Safety Recall Trucks

Date	Group.	No.	Page
06.11	SC0349		1(5)

Power Mirror Switch Failure

LEU

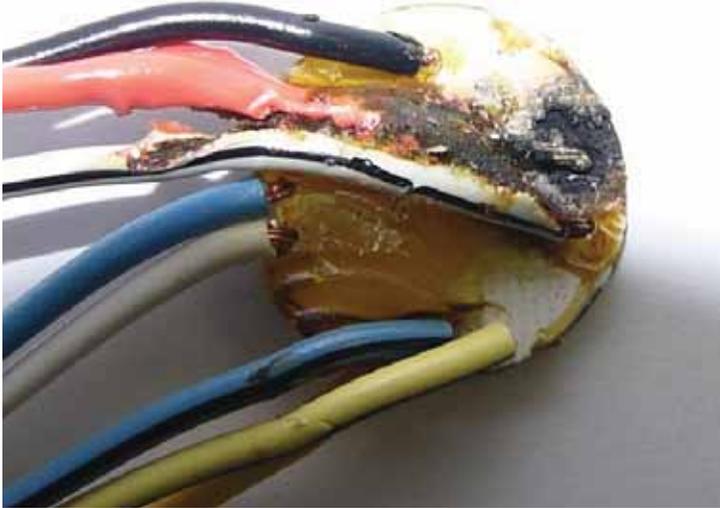
1. Disconnect all cables from the negative (ground) battery terminals to prevent personal injury from electrical shock and prevent damage to electrical components.
2. Remove the following dash panels to gain access to main harness.
 - a. Remove lower dash panel (located above brake and accelerator pedals).

- b. Remove lower A-pillar panel (located to the left of the pedals).
